Holly Street Landfill Comment Form

This is an invitation for comments on the following draft final 100% remedial design documents: **Design Analysis Report, Construction Quality Assurance Plan, and design plans and specifications** for the Holly Street Landfill. Please send your comments by March 30, 2004 to:

**Subject: Washington Department of Fish and Wildlife Comments - Holly Street
Landfill Cleanup - Whactom Creek Estuary, Tributary to Bellingham Bay,
WRIA 01.9700**

Figure 3-1
Proposed Final Layout and Grading Plan
Holly Street Landfill/Whatcom Creek Estuary Restoration
City of Bellingham Office of Neighborhoods & Community Development

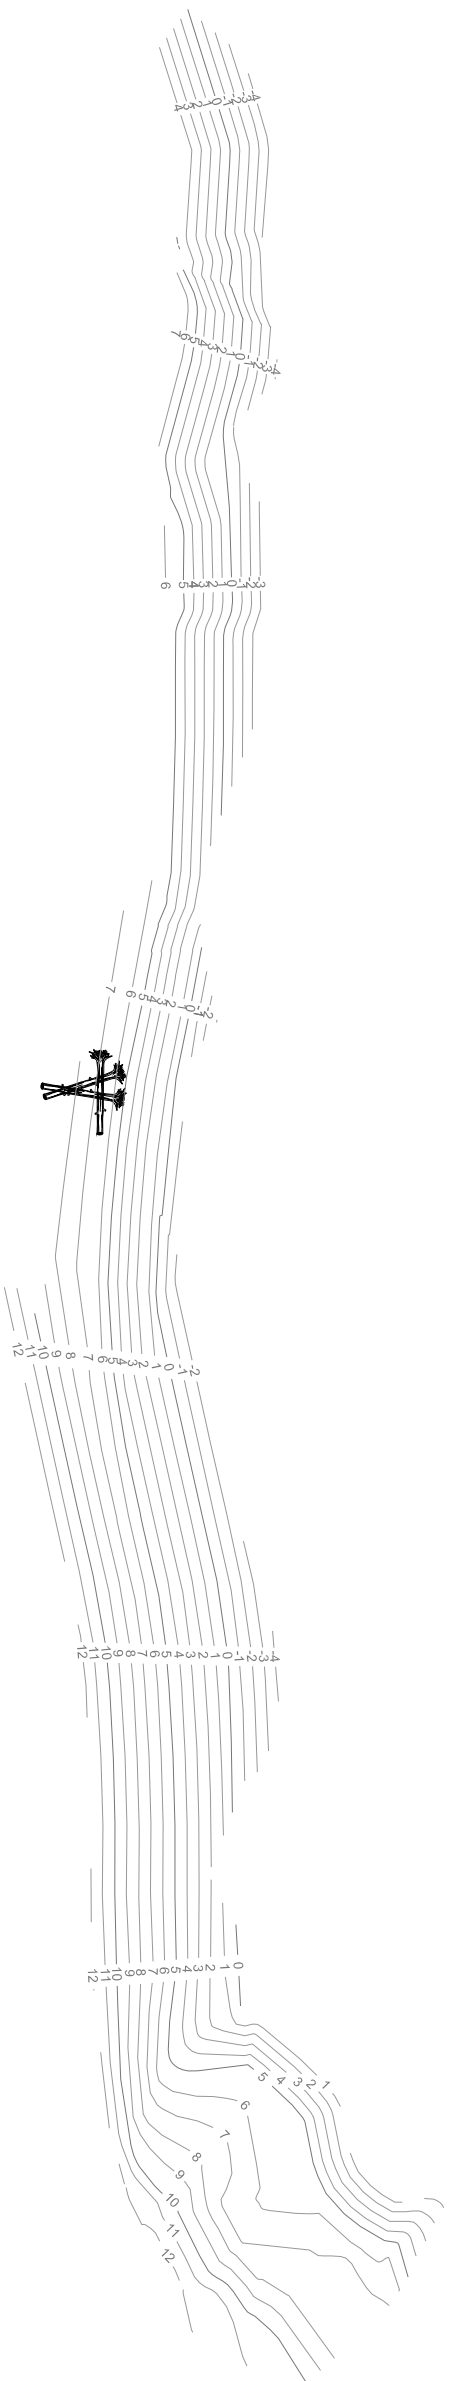
Design should include posting of large, graphic public notice - including final layout & grading plan, in a public access area during remediation. Thanks!

11. The slope of the north shoreline of Whatcom Creek should not exceed a maximum slope of 3H:1V.
12. The slope of the south shoreline of Whatcom Creek should not exceed a maximum slope of 2H:1V.

24. The proposed emergent marsh habitat bench should be created between the +10.0 and +6.0 tide elevations (MLLW = 0.00) and at a maximum 6H:1V slope as illustrated in the clean up project plans.

25. The proposed emergent marsh habitat bench between the +8.5 and +6.0 tide elevations (MLLW = 0.00) should be planted with native low marsh vegetation.

29. The top elevation for the gravel berm associated with the proposed side channel element should not exceed the +8.0 tide elevation (MLLW = 0.00) as illustrated in the cleanup project plans.
